MFD NON-COMPLIANCE REPORT # 31066-3

PART NAME: **Vacuum Chamber Assy**
PF/SA NO.: **SC-391-264-04 R1**
WORK ORDER NO.: **31066-3**
VENDOR **Nor Cal**

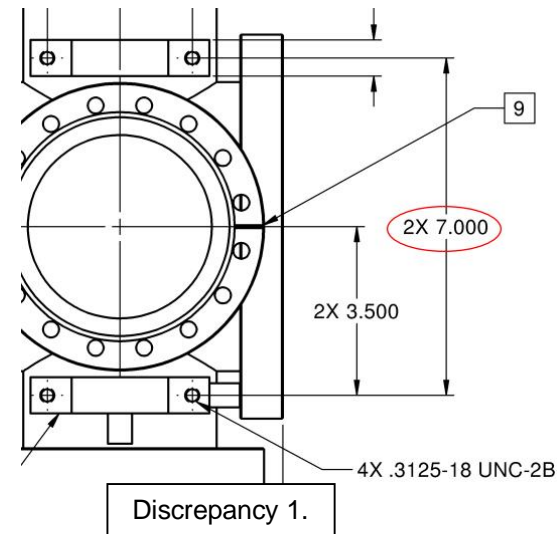
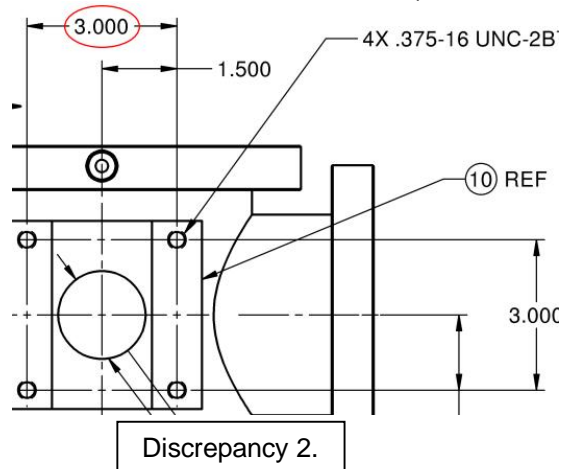
1. 2X 7.000 ± 0.005 of 5/16-18 UNC-2B Threaded Holes measure 6.9670 (-0.028" out of tolerance).
 - a. 5/16-18 UNC-2B Threaded Holes had to be chased (Thread Burrs). Ok now.
2. Distance 3.000 ± 0.005 of 3/8-16 UNC-2B Threaded Holes measured 3.0135 (+0.0085" out of tolerance).

Action (UAI,RWK,SCRIP)
